CROWN STREET WOLLONGONG

RTS DESIGN RESPONSE
WOLLONGONG DEVELOPMENTS NO.8 PTY LTD

RtS DESIGN RESPONSE PURPOSE

DPHI-1.1

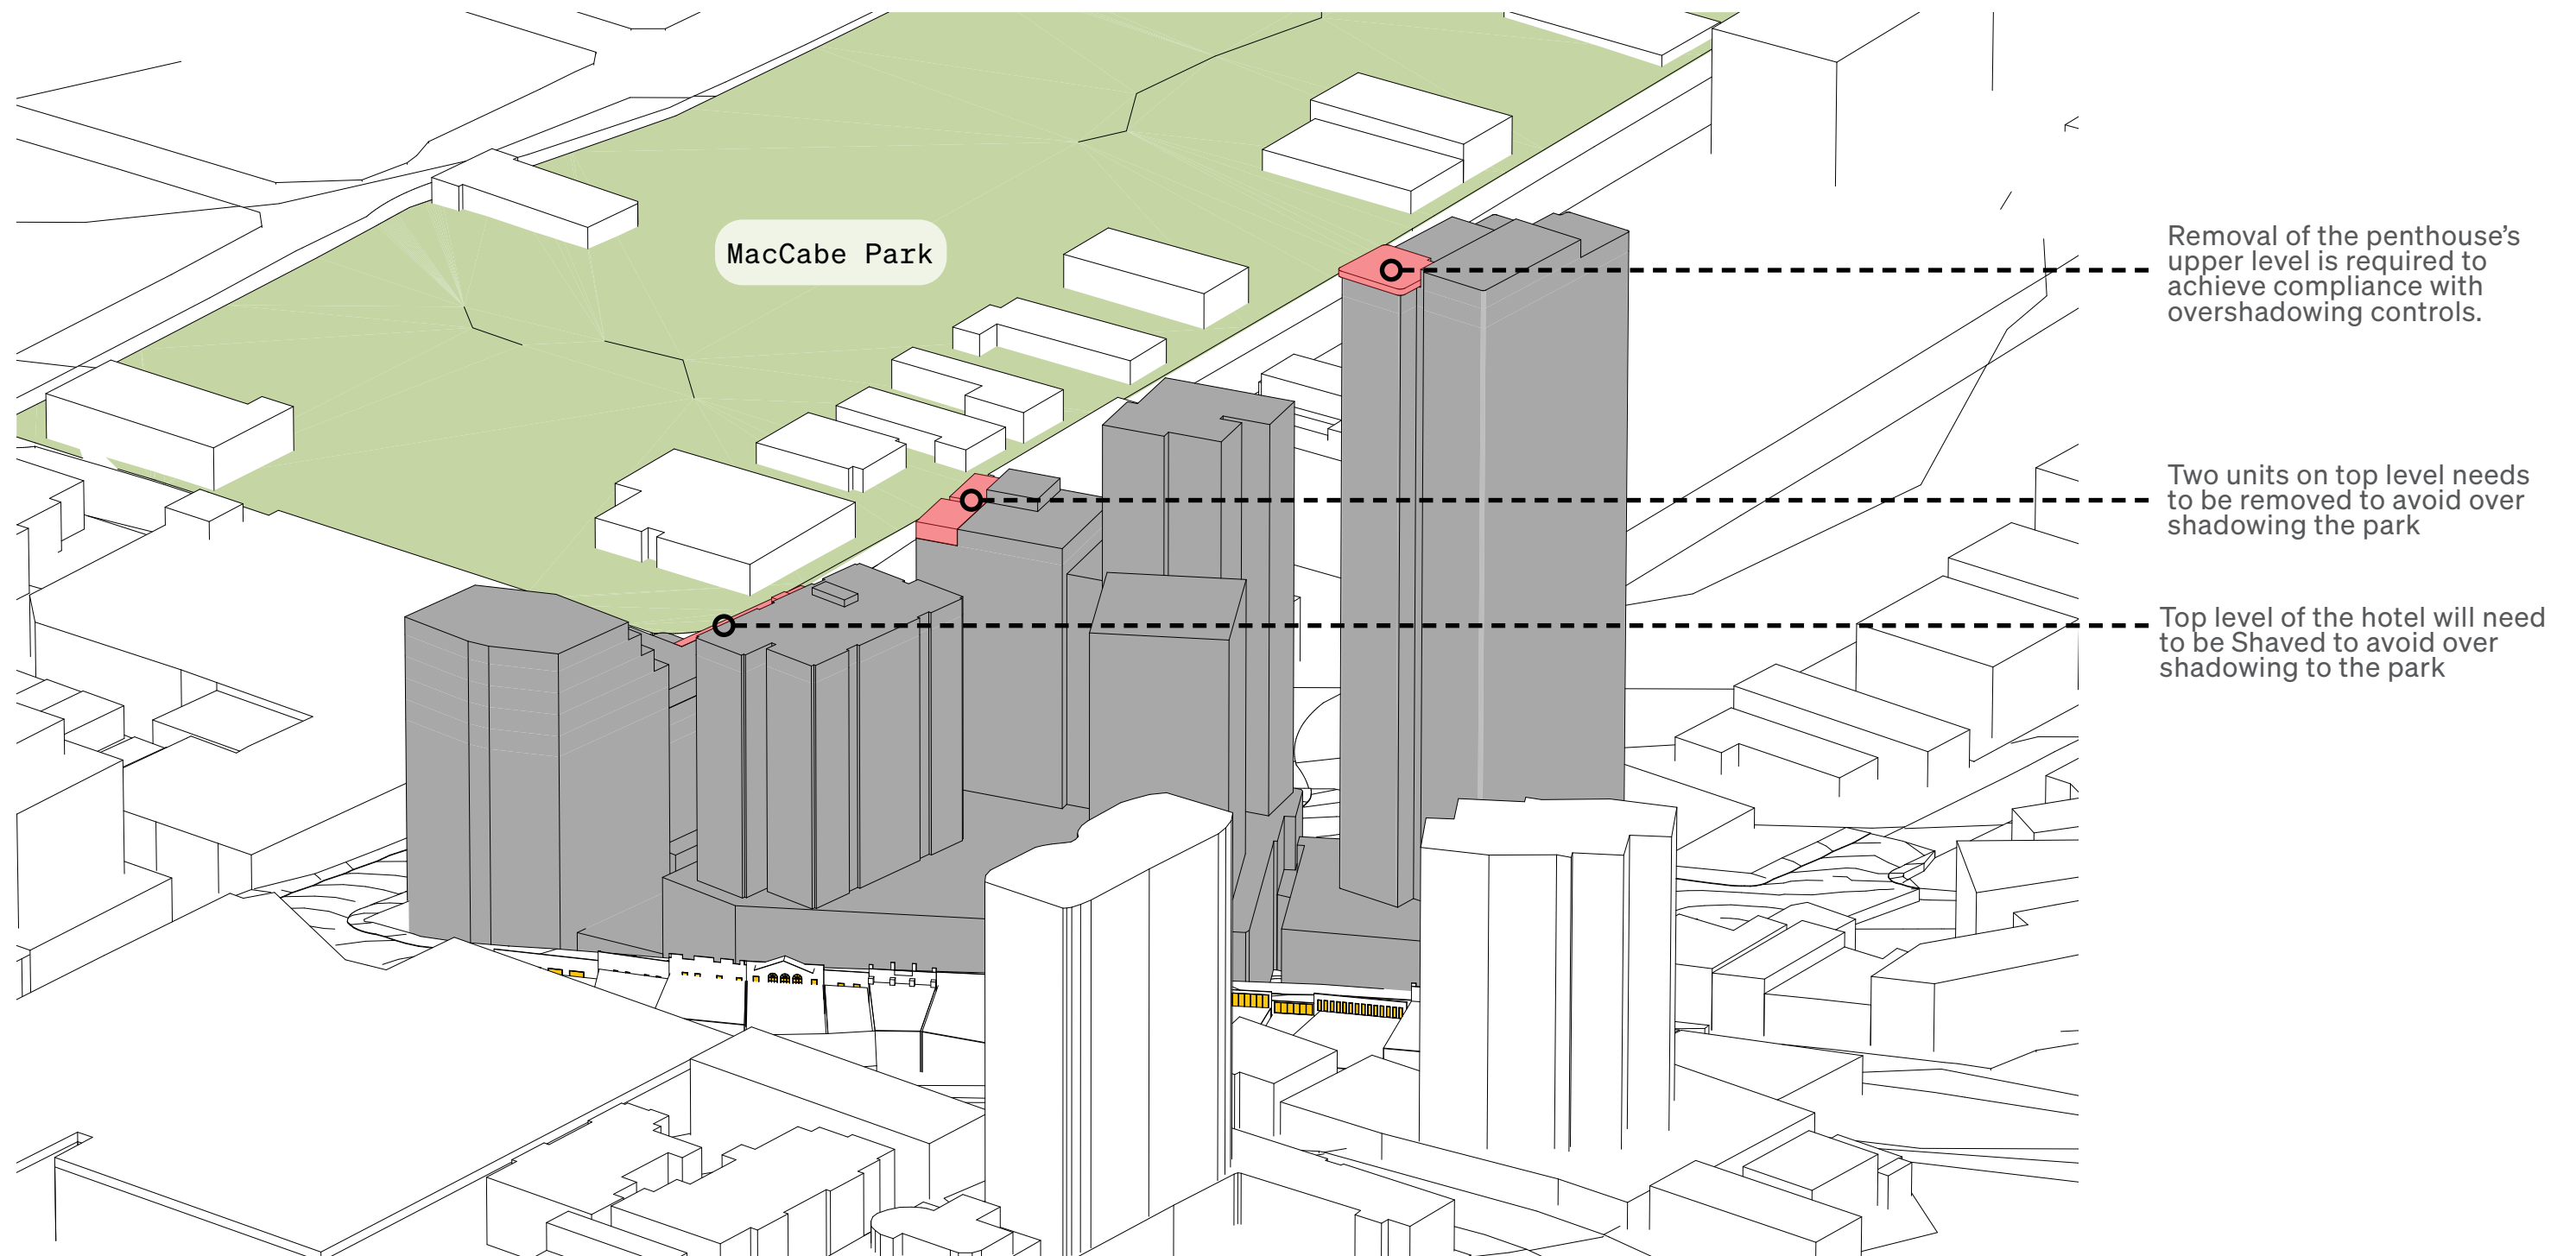
Amend the proposed building heights to ensure the proposal complies with the sun access plane to MacCabe park, as detailed in Clause 8.3 of the LEP, and Demonstrate no overshadowing of MacCabe Park occurs between 12-2 pm midwinter.

The development has been amended to avoid overshadowing of the park between 12:00 pm and 2:00 pm during midwinter. The changes include reducing the height of Building 1 where it previously impacted the park. In addition, units within Building 2.2 have been removed and the hotel roof level has been amended to eliminate overshadowing of the park during this period.

DPHI-1.3

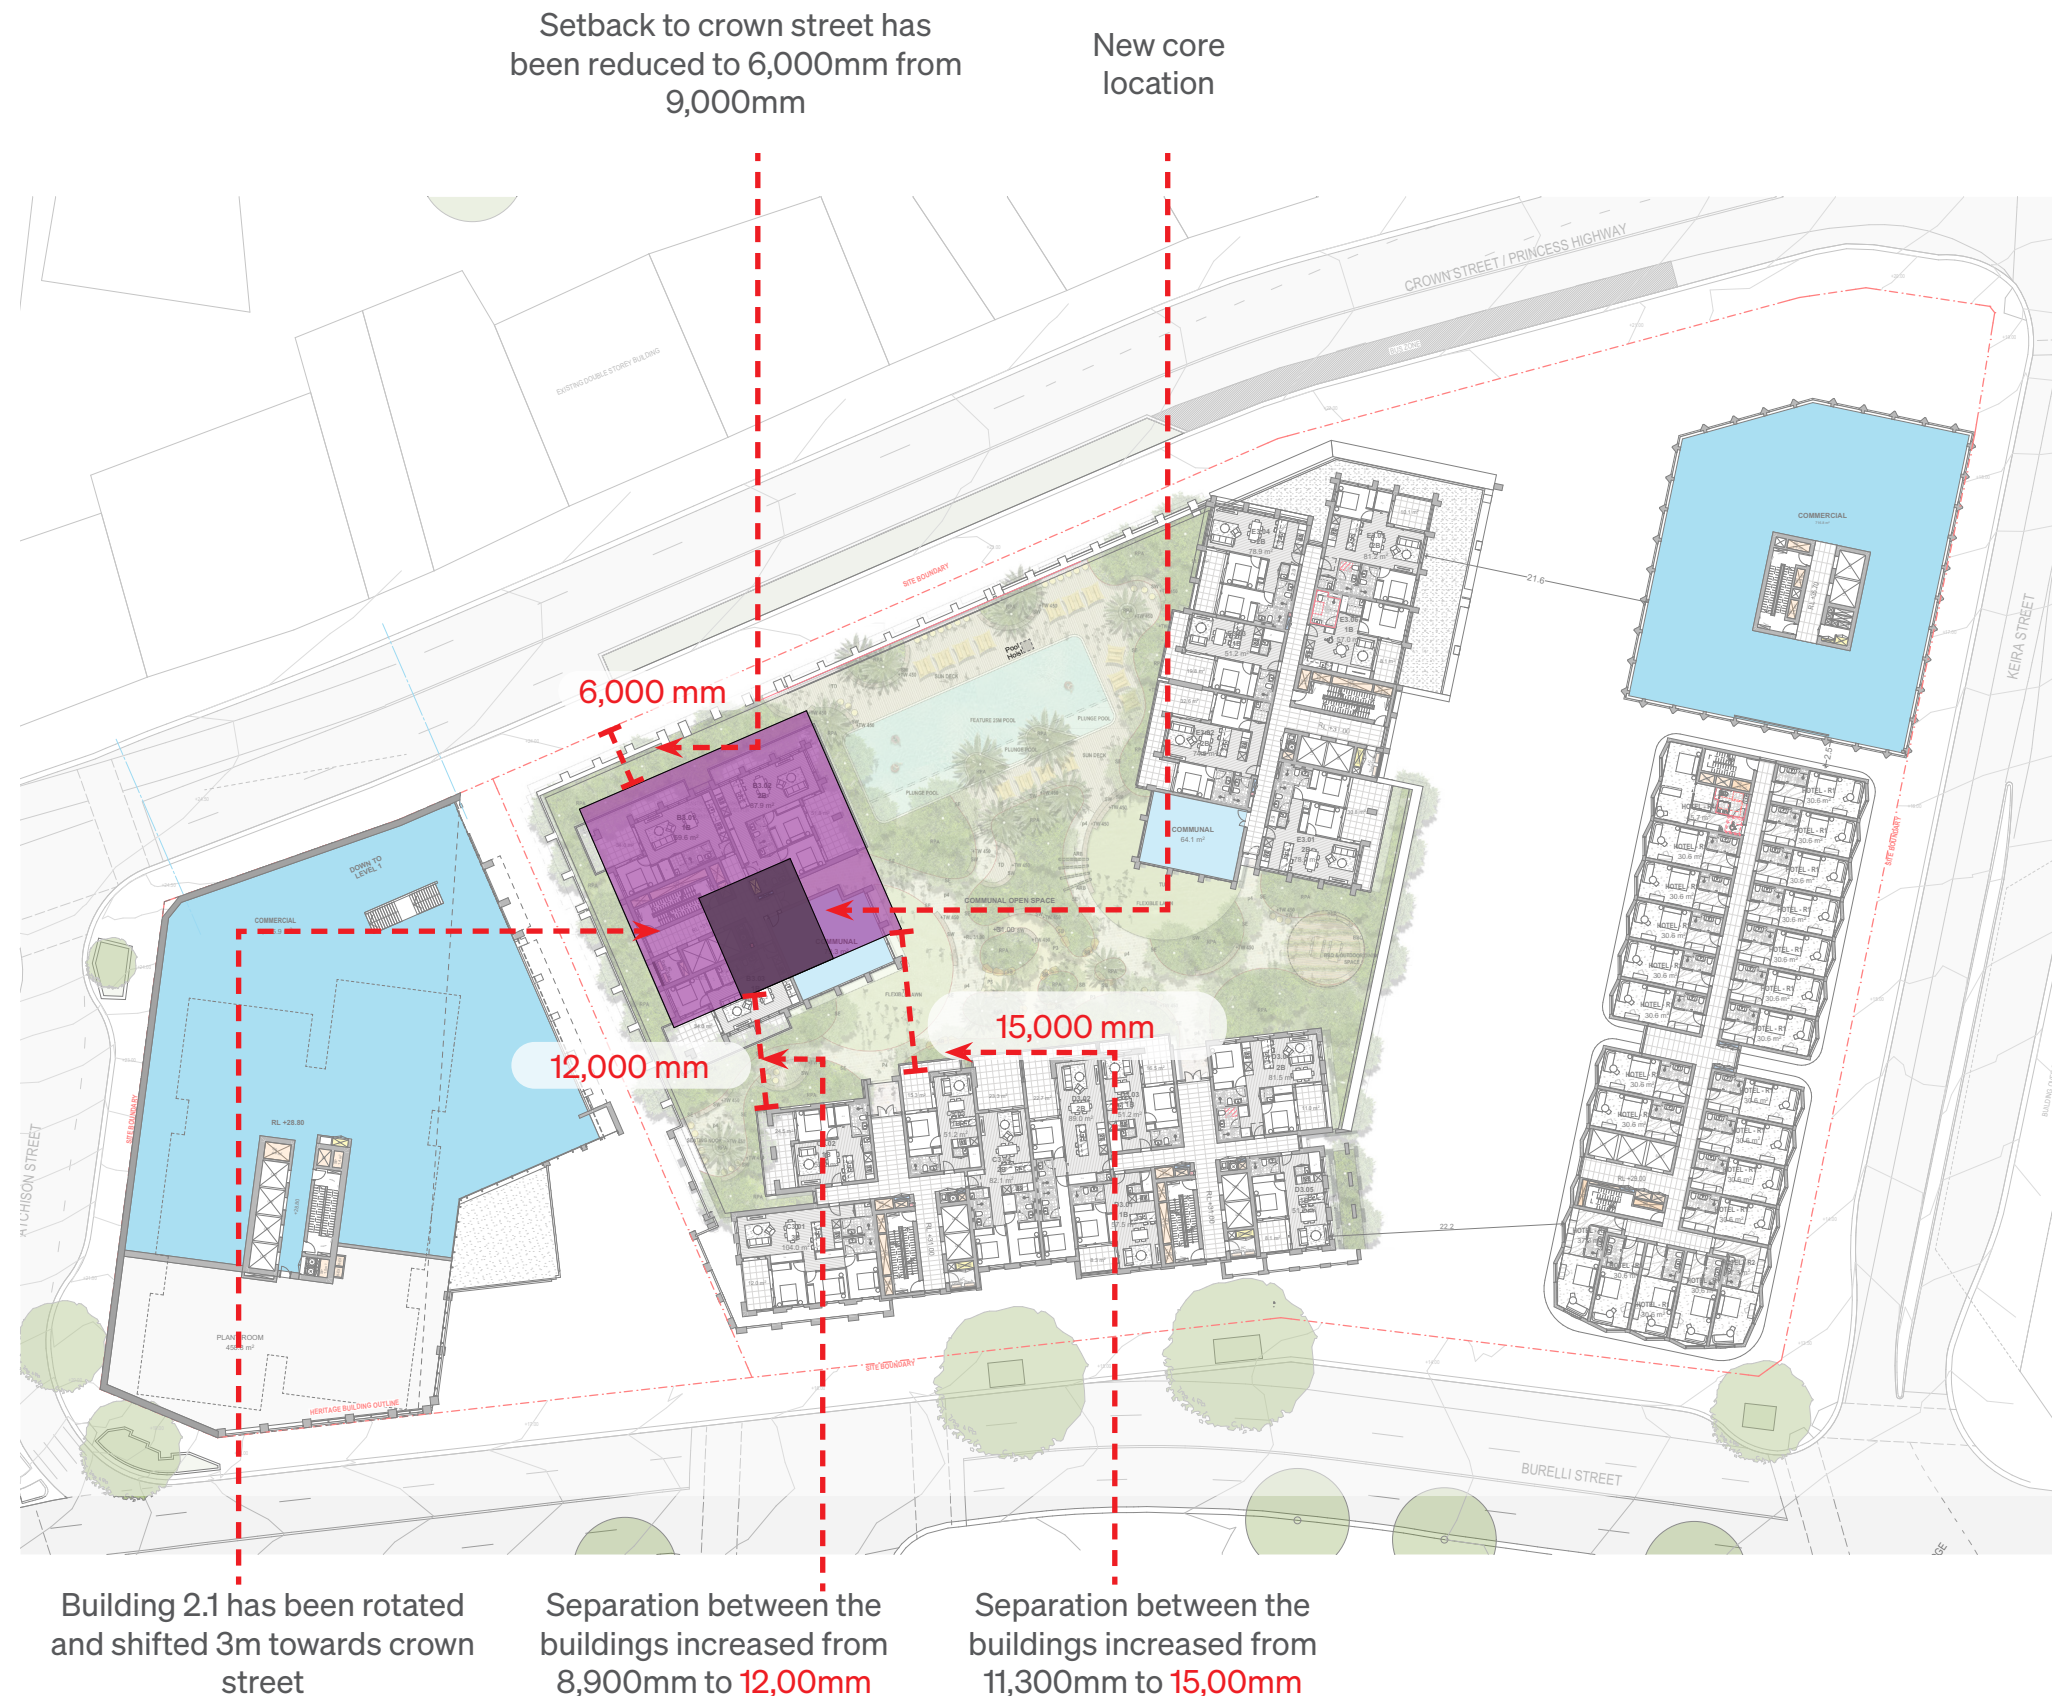
Concern is raised about the proposed building separation distance between Buildings 2.1 and 2.2. In this regard, the Department requests further consideration of:

- options to adjust the proposed towers to enhance building separation, including shifting or reorienting the buildings
- the inclusion of additional privacy measures including window treatments (such as angled bay windows), reoriented openings, and considering alternative dwelling layouts to minimise overlooking.

The separation between Building 2.1 and Building 2.2 has been enhanced by rotating Building 2.1 in an anticlockwise direction and reducing its setback to Crown Street by 3 meters.

The proposed location of the lift core on Building 2.1 has been relocated to the southern facade improving privacy on habitable windows on Building 2.2, reducing direct overlooking. Additionally, by reducing the setback to Crown Street has enabled an increased separation distance between Building 2.1 and Building 2.2.

Further privacy measures have also been incorporated into the design, including privacy screens to habitable room windows and balconies, to minimise overlooking and maintain residential amenity.

Building 2.1 - Floor plans view privacy treatment

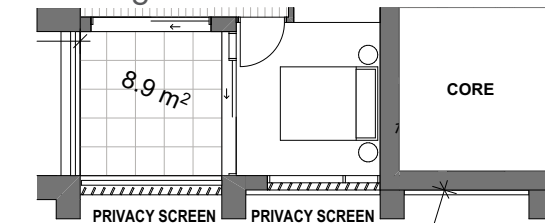
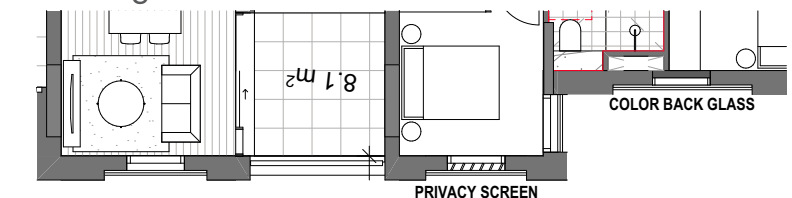
Concern is raised about the proposed building separation distance between Buildings 2.1 and 2.2. In this regard, the Department requests further consideration of:

- options to adjust the proposed towers to enhance building separation, including shifting or reorienting the buildings
- the inclusion of additional privacy measures including window treatments (such as angled bay windows), reoriented openings, and considering alternative dwelling layouts to minimise overlooking.

The separation between Building 2.1 and Building 2.2 has been enhanced by rotating Building 2.1 in an anticlockwise direction and reducing its setback to Crown Street by 3 meters.

The proposed location of the lift core on Building 2.1 has been relocated to the southern facade improving privacy on habitable windows on Building 2.2, reducing direct overlooking. Additionally, by reducing the setback to Crown Street has enabled an increased separation distance between Building 2.1 and Building 2.2.

Further privacy measures have also been incorporated into the design, including privacy screens to habitable room windows and balconies, to minimise overlooking and maintain residential amenity.

Level 01 plan
RtS Amendment

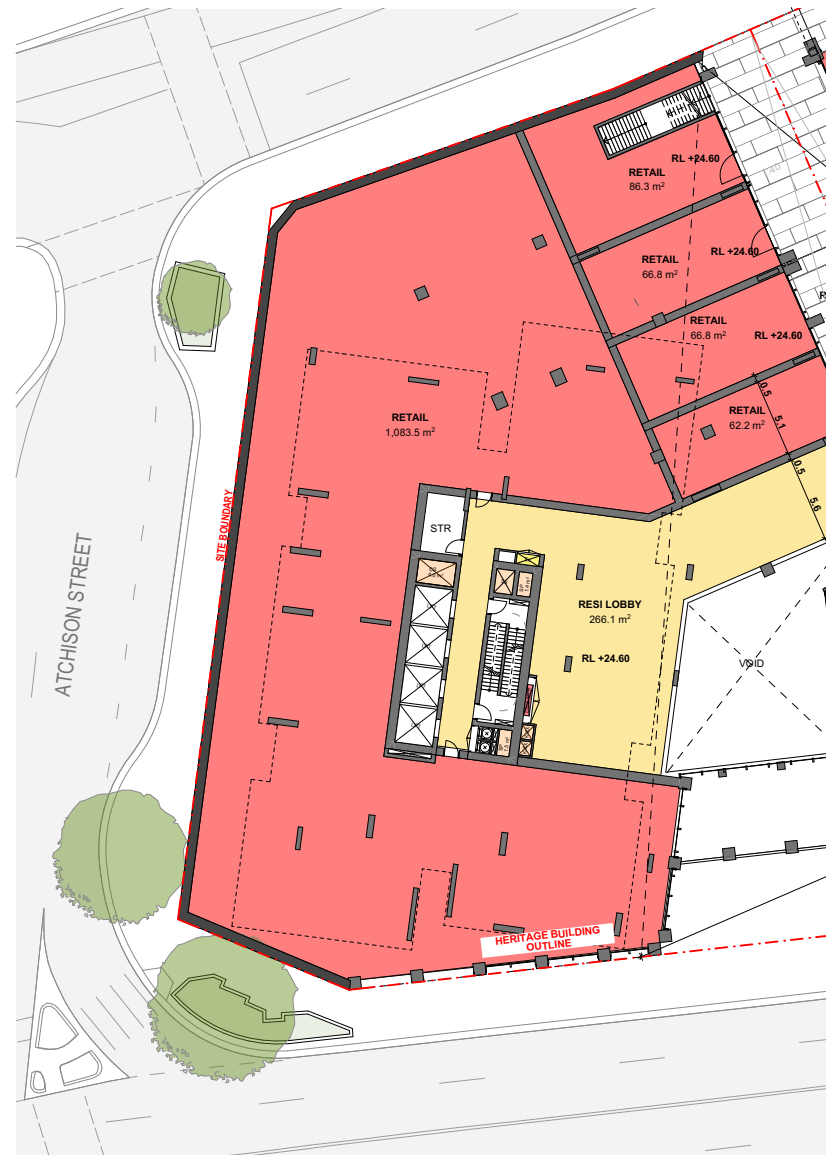
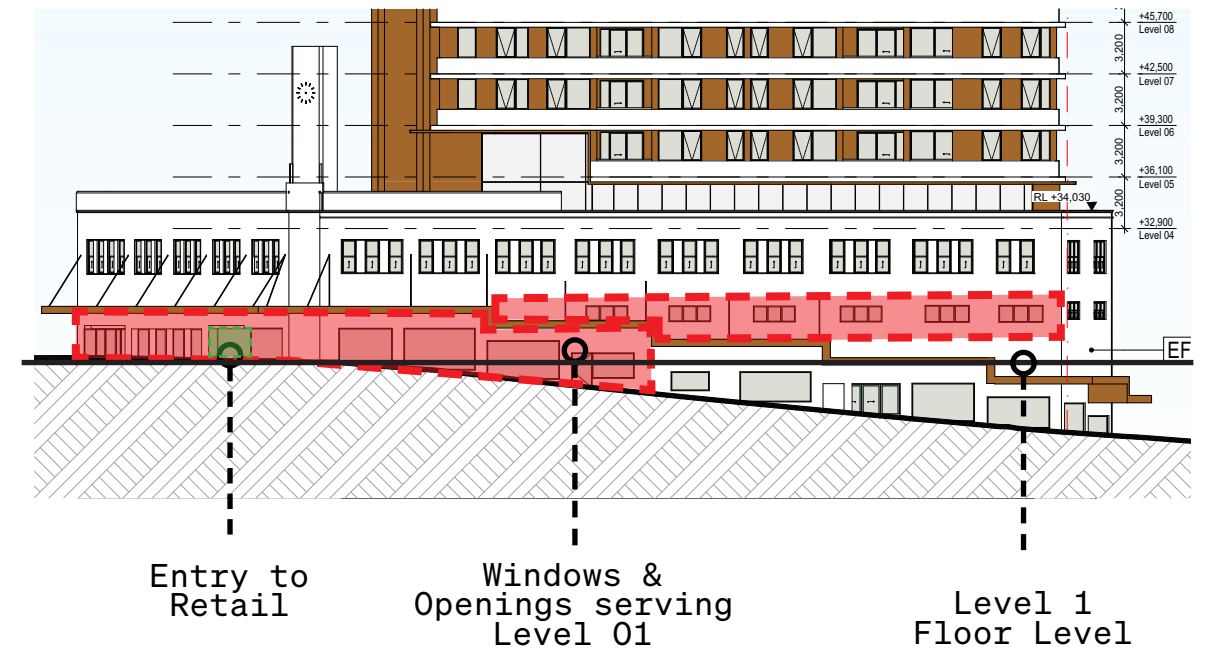
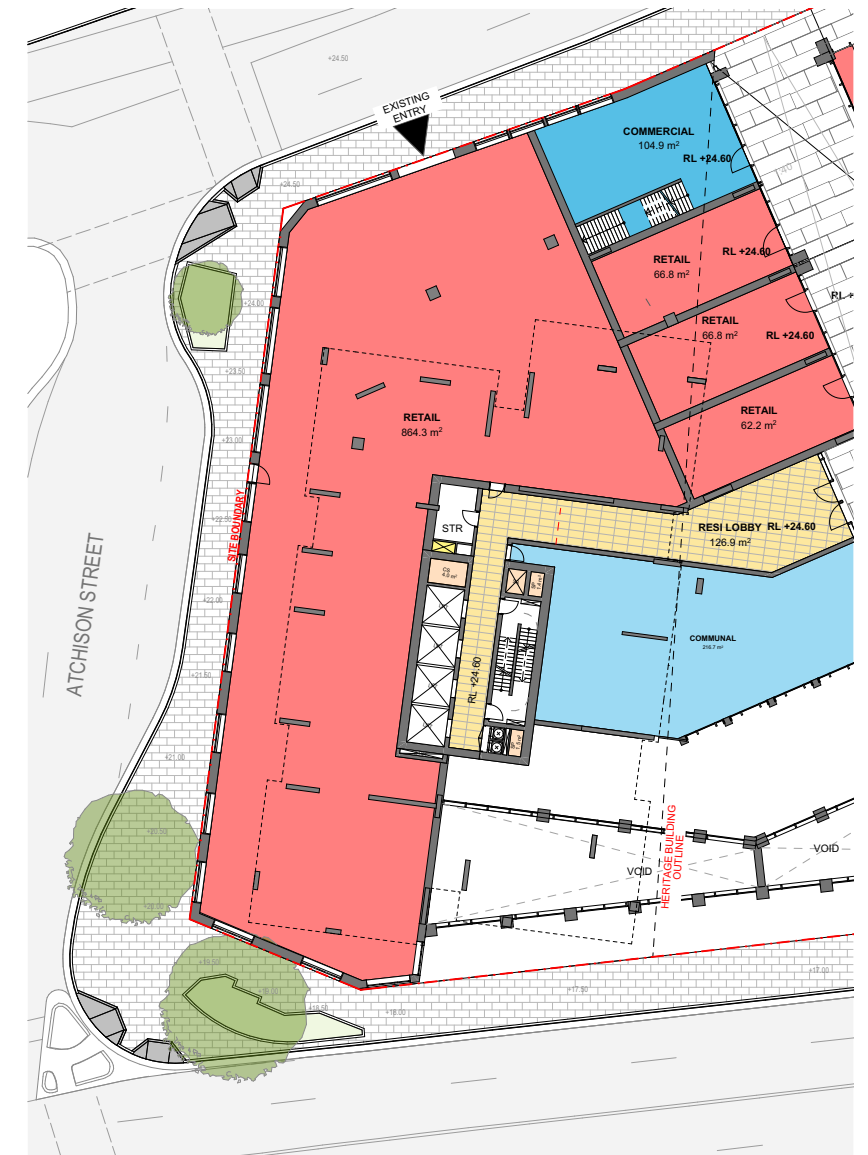
Provide active uses along the ground level of the Marcus Clarke Building, to support its adaptive reuse and contribute positively to the Crown Street CBD street scape.

The interface of the Marcus Clark Building has been refined to enhance its presentation and relationship with the public domain. Along Crown Street, the upper-level access stair has been recessed to improve the building frontage. Existing windows along Atchison Street that were previously obscured have been reopened to reinstate the building's historic façade rhythm and provide increased passive surveillance. The Building 1 fire stair egress has been relocated to minimise its impact on Atchison Street, while the adjacent retail tenancy has been reconfigured to provide direct street access at the corner of Atchison and Burelli Streets, creating a more active and engaging street interface.
